# SALEM GENERATING STATION

## OFFSITE DOSE CALCULATION MANUAL (ODCM) FOR STATION RADIOACTIVE EFFLUENT CONTROLS (REC) (PSEG NUCLEAR, LLC)

Revision 30

**Revision Summary:**

FIGURE 1.1: Area Plot Plan of Site

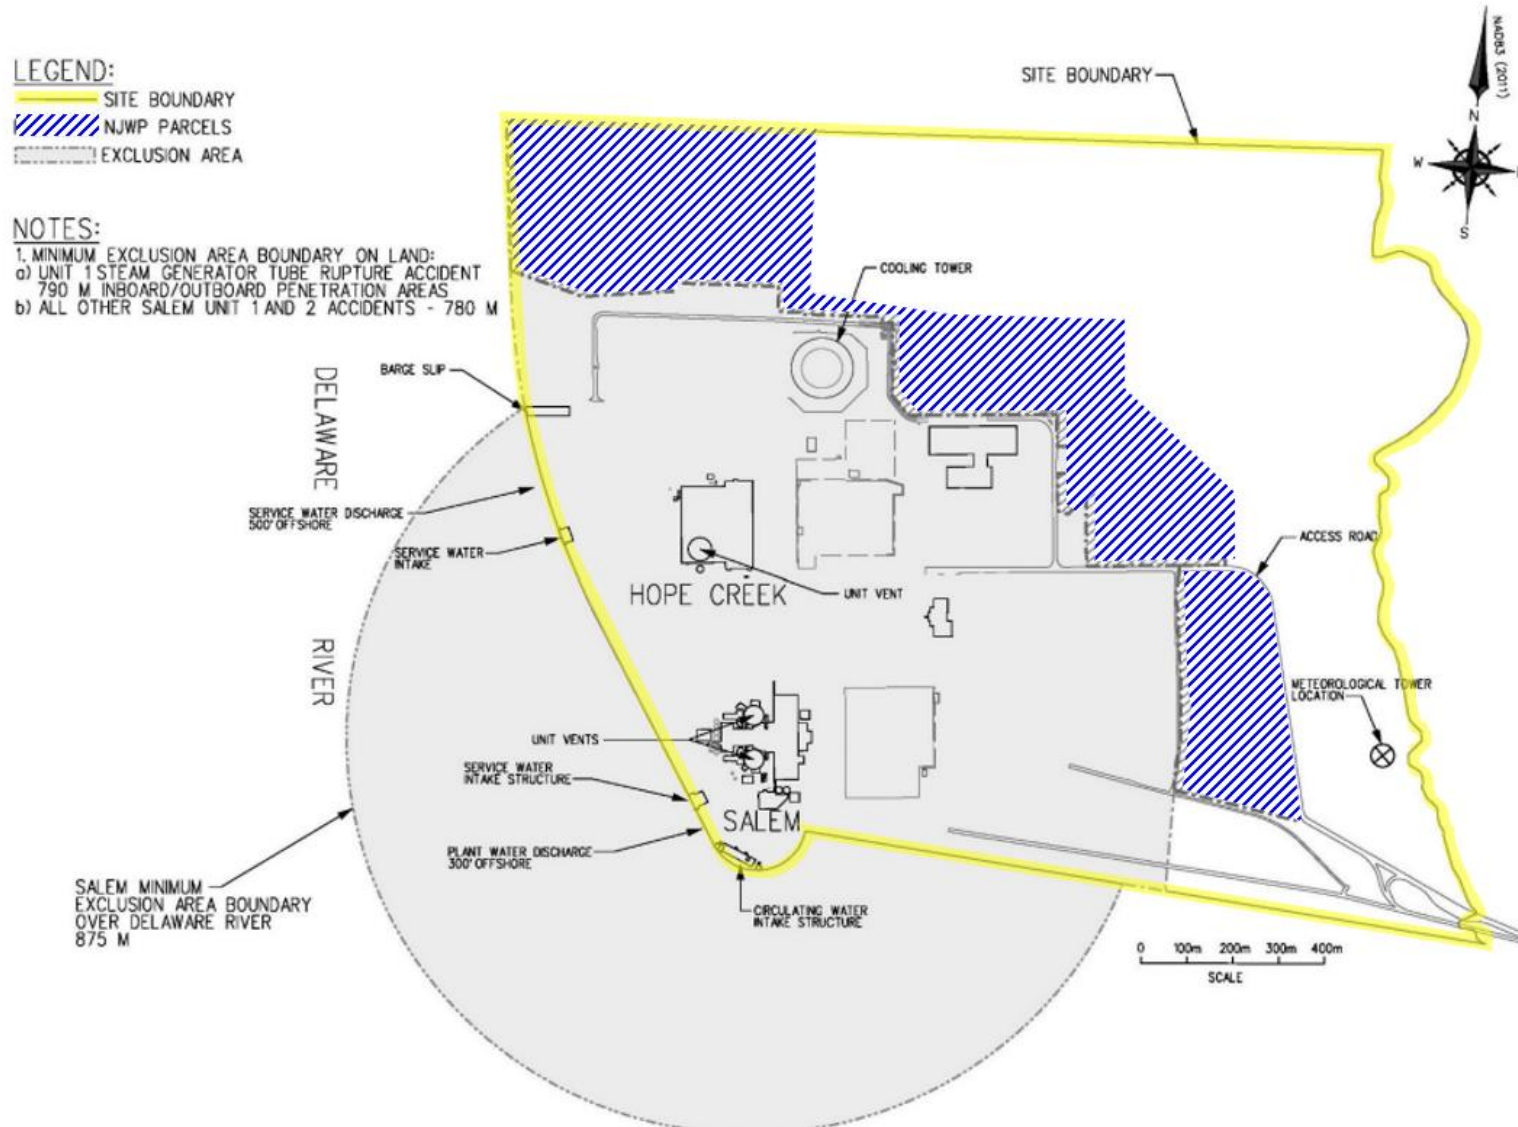
5.	46	8	Moved Figure 5.1-3 to the end of Section 1 Definitions. Renamed Figure to Figure 1.1 Updated the site map showing the new EAB for the Wind Port project. <u>Reason:</u> Section 5.0 Design Features was eliminated from the ODCM as not needed. That section is in Tech Specs and is overriding. The Figure 5.1-3 name changed to Figure 1.1, because the figure was moved from Section 5 (which is deleted) to Section 1 (Definitions). The land was transferred to the State of New Jersey	Editorial

FIGURE 1-1: Liquid Release Flow Path Unit 1

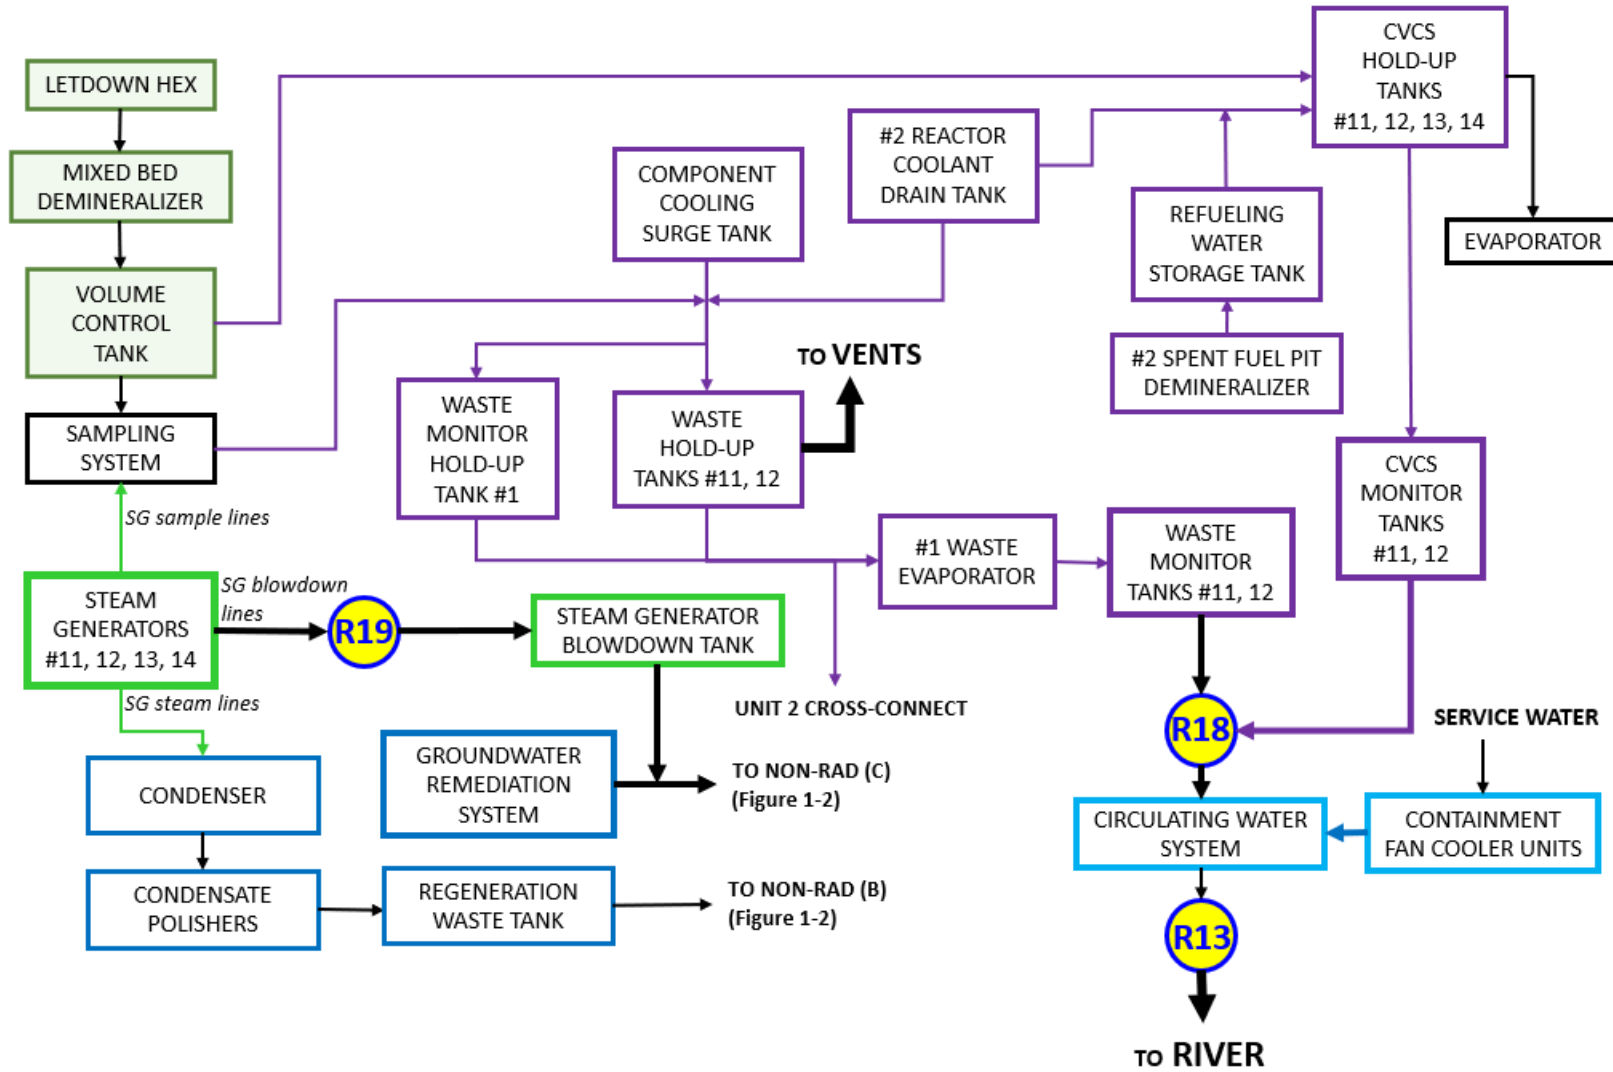
17.	69-70	67-68	<p>Updated Figure 1-1 Liquid Release Flow Path Unit 1 and Figure 1-2 Liquid Release Flow Path Unit 2 to add the Regeneration Waste Tank before release to the Non-Rad discharge.</p> <p><u>Reason:</u> Editorial update</p>	Editorial
